**Subject:** DEIR Public Comment to the Proposed Accretive Lilac Hills Ranch General Plan Amendment and Specific Plan PDS2012-3800-12-001(GPA), PDS2012-3810-12-001 (SP), DEIR Chapter 2 Analysis of **Cumulative Impacts** of the proposed Lilac Hills Ranch (LHR) Project

**Subject:** DEIR Public Comment to the Proposed Accretive Lilac Hills Ranch General Plan Amendment and Specific Plan PDS2012-3800-12-001(GPA),PDS2012-3810-12-001 (SP), Fire Protection Plan, Evacuation Study, and DEIR Chapter 2.7 Hazards

**Subject:** DEIR Public Comment to the Proposed Accretive Lilac Hills Ranch General Plan Amendment and Specific Plan PDS2012-3800-12-001(GPA), PDS2012-3810-12-001 (SP), DEIR Chapter 2.8 Noise; Noise Report of the proposed Lilac Hills Ranch (LHR) Project

**Subject:** DEIR Public Comment to the Proposed Accretive Lilac Hills Ranch General Plan Amendment and Specific Plan PDS2012-3800-12-001(GPA), PDS2012-3810-12-001 (SP), EIR Project Objectives

Table 12 - "FUTURE OFF-SITE NOISE LEVELS AT SPECIFIC LOCAL RECEIVER LOCATIONS" p. 47 of Noise Report is presented as the basis for ADT traffic volume for modeling the LHR project Traffic Generated Noise.

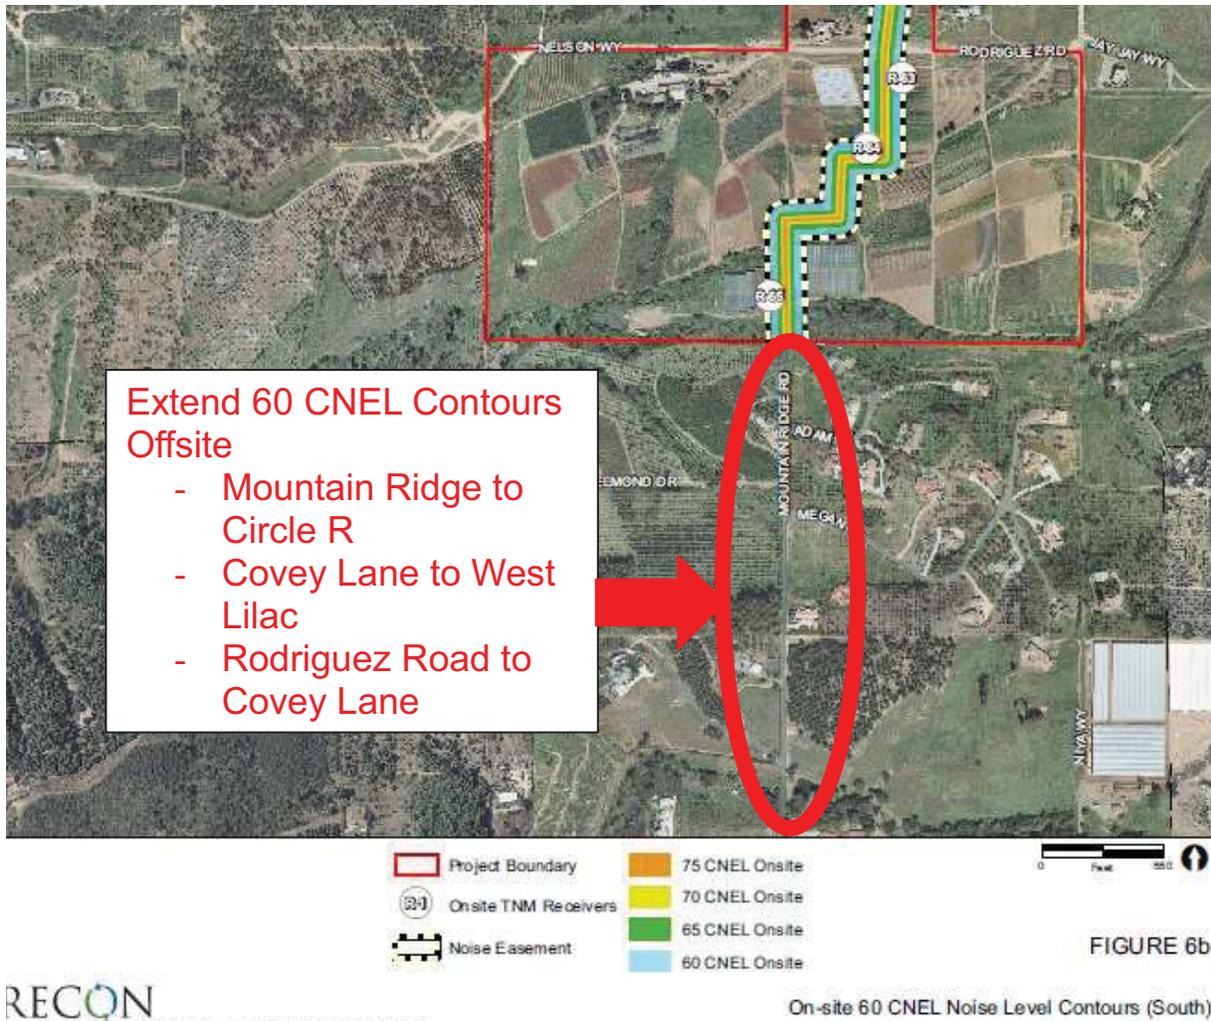
The August 16, 2013 Darnell Associates Independent Expert review of the Chen Ryan Traffic Impact Study submitted as Public Comments for the LHR DEIR presents factual evidence that the Chen Ryan Traffic Impact Study (TIS) understated the Traffic volume and distribution.

In summary, the Chen Ryan TIS understated ADT trip generation 11.9%. Additionally, Chen Ryan overstated internal trip capture, which would change ADT distribution assignment to area roads. Further, the Darnell August 16, 2013 Independent Study assigns far greater traffic volume to Mountain Ridge and Covey Lane Private Roads, where a large population of Offsite NSLU receivers are located.

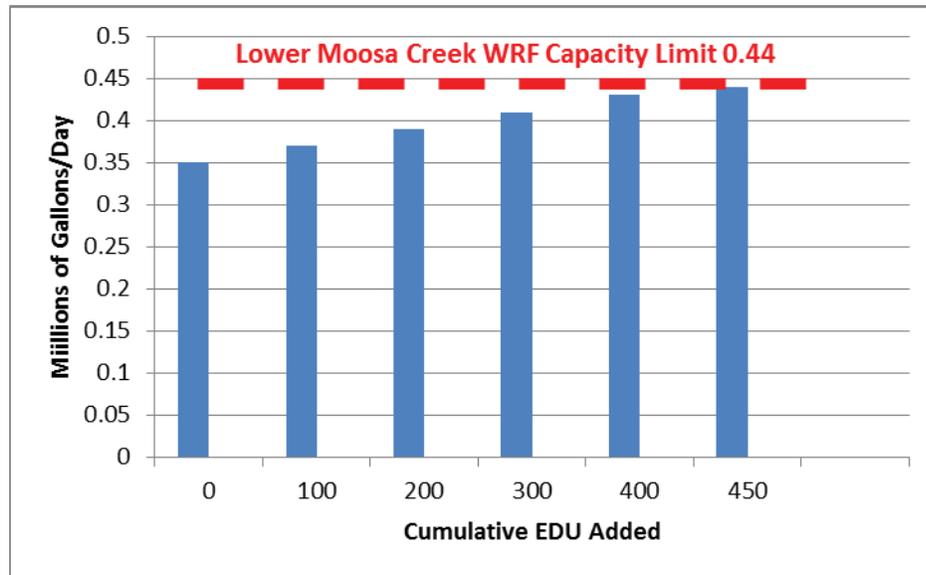
The current capacity of LMRWF is 0.5 MGD of sewage influent treatment and is presently at 0.35 MGD average reclaimed secondary treated water.

The present ground water percolation pond capacity is 0.44 MGD.

The present capacity of LMWRF allows addition of a maximum of 450 Equivalent Dwelling Units (EDU's) until secondary percolation ponds are at full permit capacity. See Graph below:

Question 5): It is our understanding that the Regional Water Quality Control Board (RWQCB) may not allow an expansion to the current 0.44 MGD limit on the percolation ponds. Is this correct? In your response, please provide details of current Basin and Sub Basin capacity, present Surface and Groundwater Quality (detail of TDS by element, heavy metals, and biological organisms) for relevant Basins and Sub Basins. Please provide RWQCB's detailed analysis of concerns on any proposed expansion of the LMWRF percolation pond capacity for additional disposal of secondary disinfected recycled water beyond the current 0.44 MGD cap.
